UNITED STATES
ATOMIC ENERGY COMMISSION
WASHINGTON, D.C. 20545

Change No. 12
License Nos. DPR-31 and 41

By letters dated October 15 and November 23, 1973, you proposed certain changes to the Technical Specifications attached as Appendix A to Facility Operating Licenses DPR-31 and 41. By this action, which is designated Change No. 12, we dispose of these proposals as described below.

Re: Turkey Point Plant Units 3 and 4
Docket Nos. 50-250 and 50-251

MANAGEMENT ORGANIZATION CHART
FIGURE 6.1-1

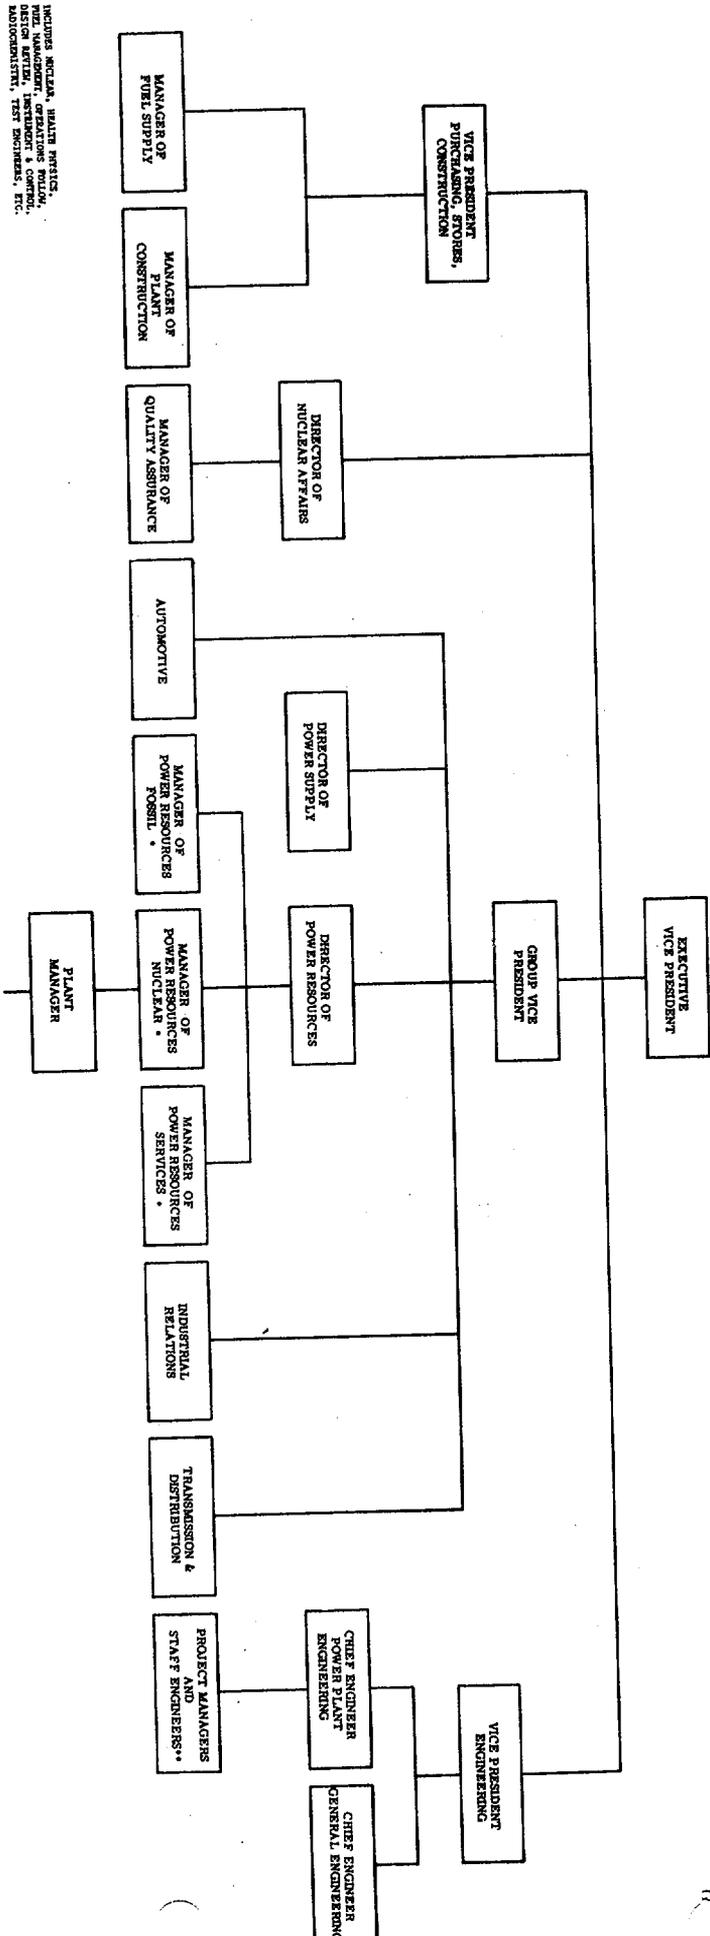
Figures 6.1-1 thru 6.1-3

These have been updated to show the current organization and titles.
